Bid 622
**Rancho Campana High School HVAC Modernization Project for Oxnard
Union High School District**

ADDENDUM #2

Dated: June 12th, 2020

2
A1.04

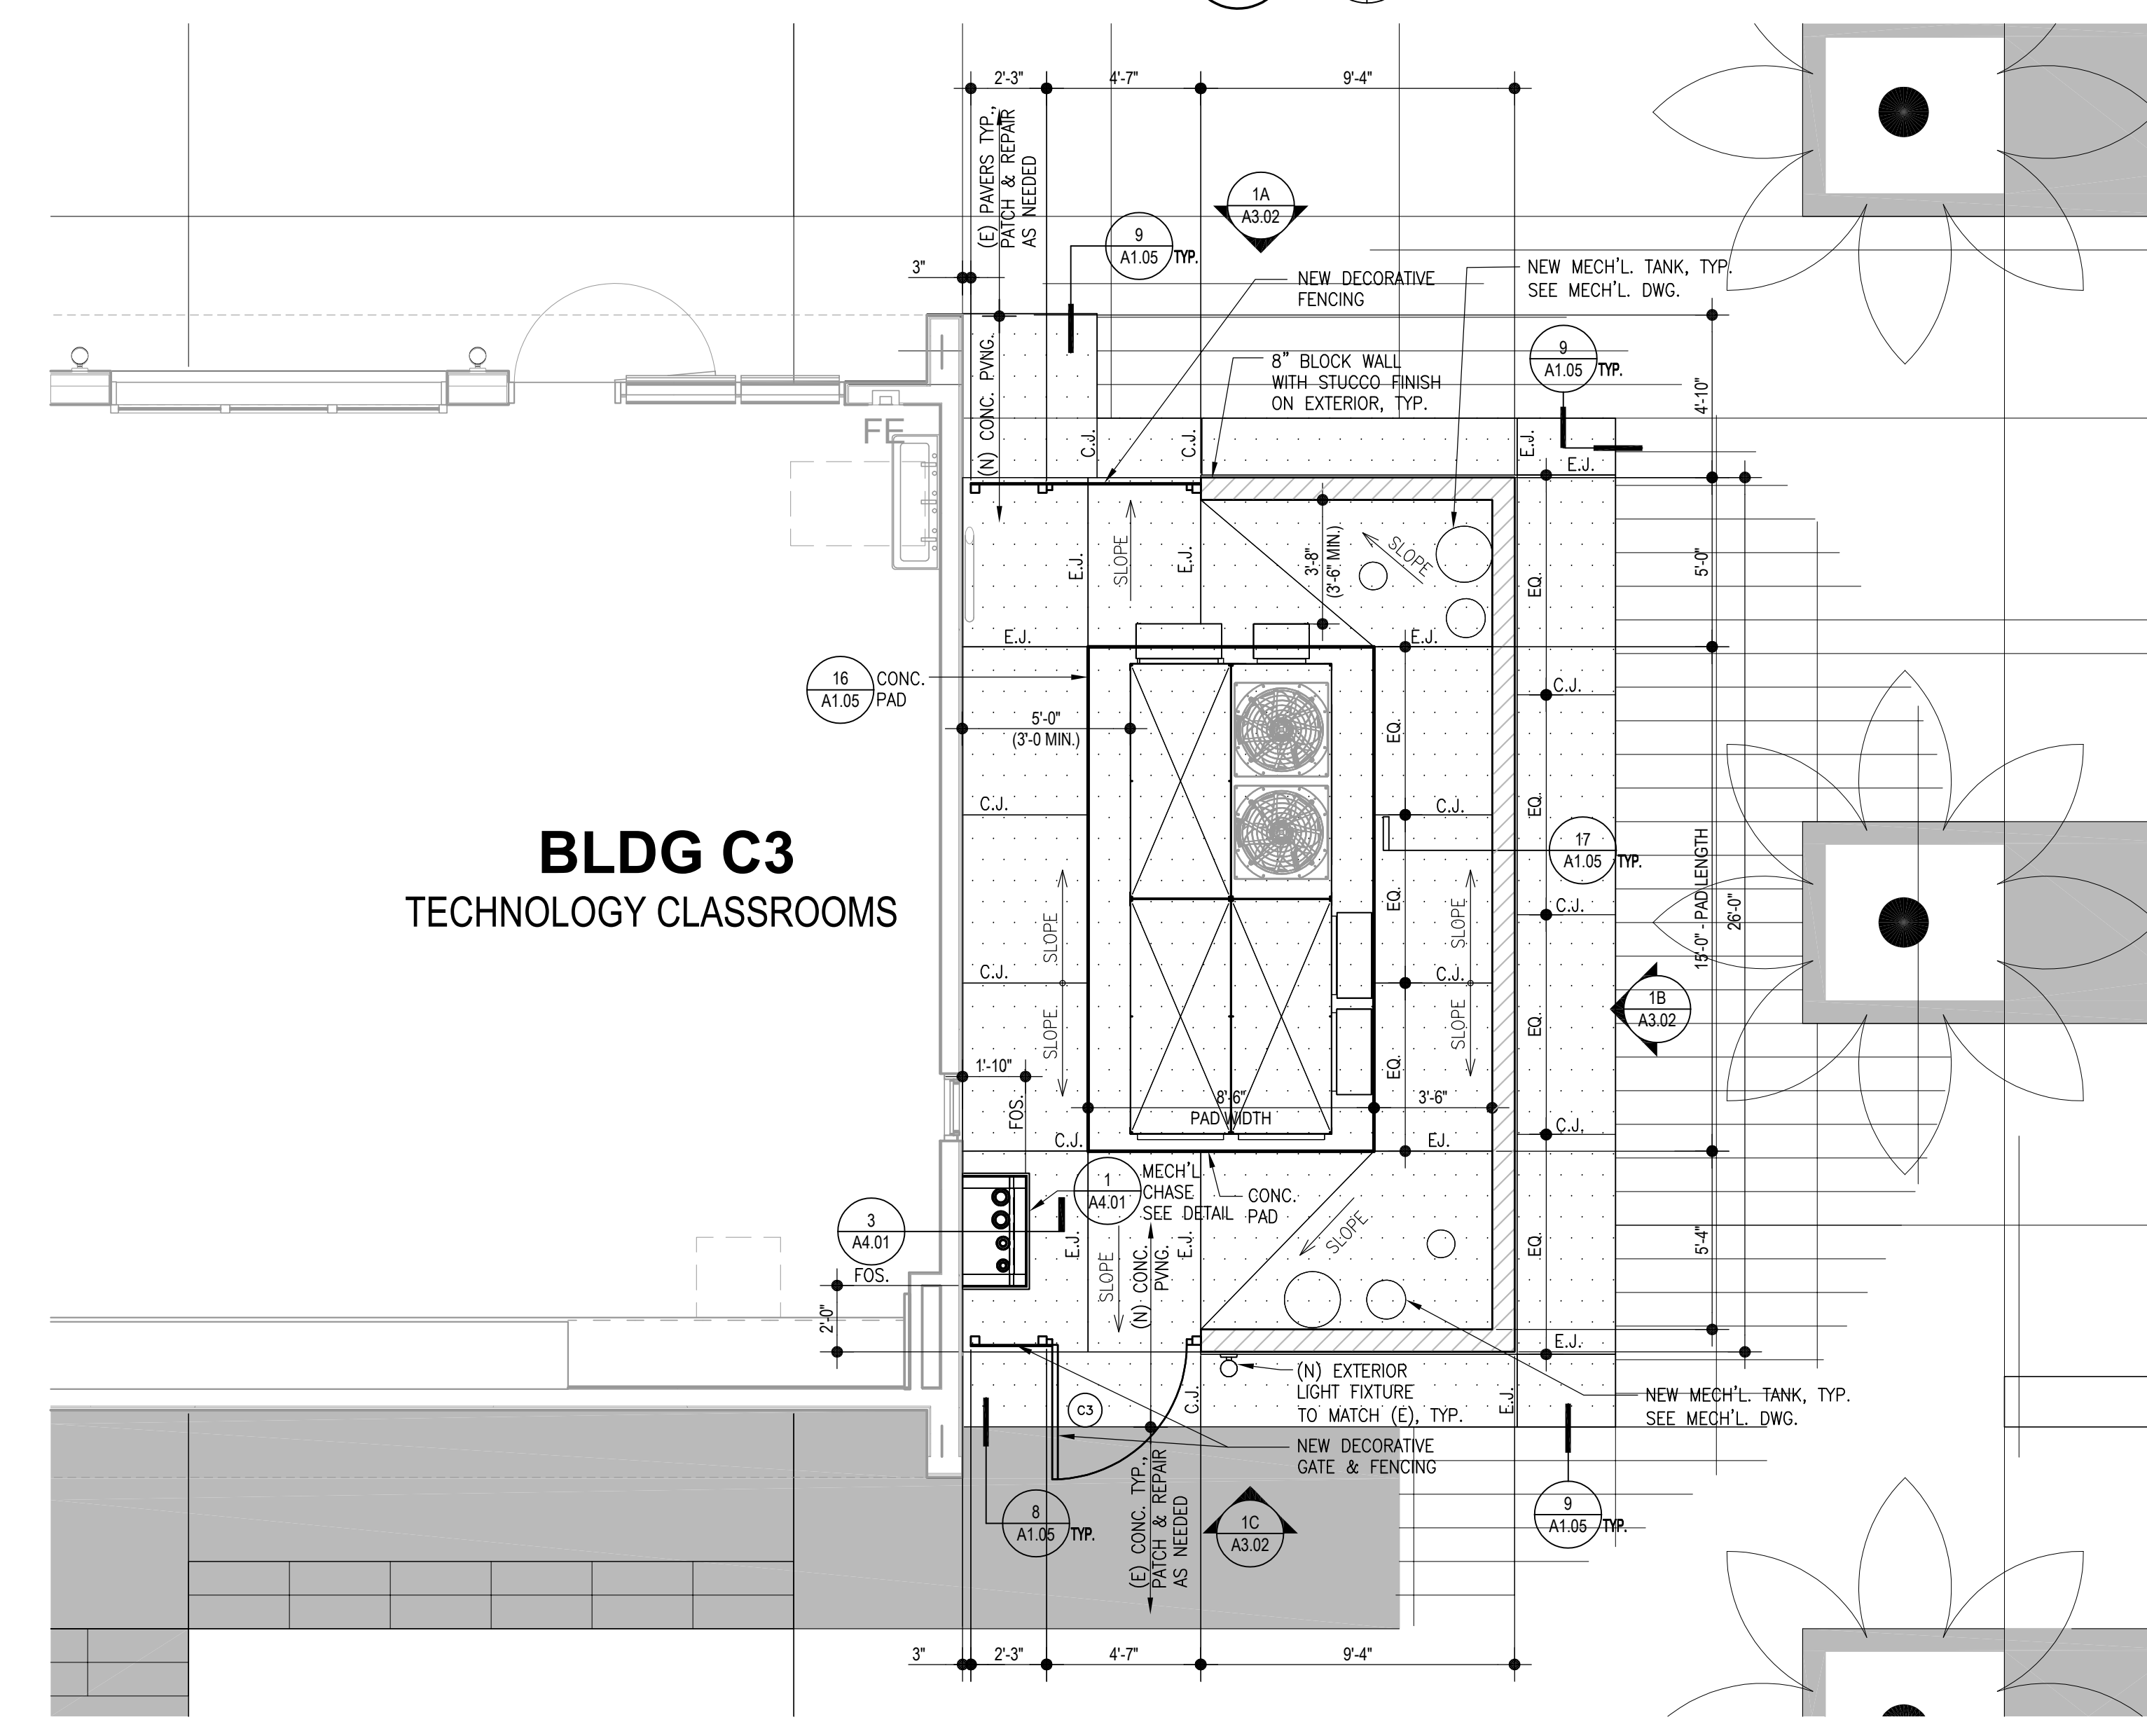
- 8) **Question: Los Angeles Air Conditioning, Inc. RFI #02 Referencing: Bldg. E piping enclosure drawing M4.03 at Grids (E-F) x (E-17.3).** At this location you have a glass window and we don't think the pipe will fit above this window. If this is your intent, please show a detail and direction on how to build this pipe chase alongside this window.

Referencing: Bldg. E piping enclosure drawing M4.03 at Grids (E-F) x (E-17.3)
At this location you have a glass window and we don't think the pipe will fit above this window.
If this is your intent, please show a detail and direction on how to build this pipe chase alongside this window?

New detail and information will be provided as part of Addendum to be issued. (See attachment I)
Sam Sahand - Flewelling & Moody - 06/05/2020.
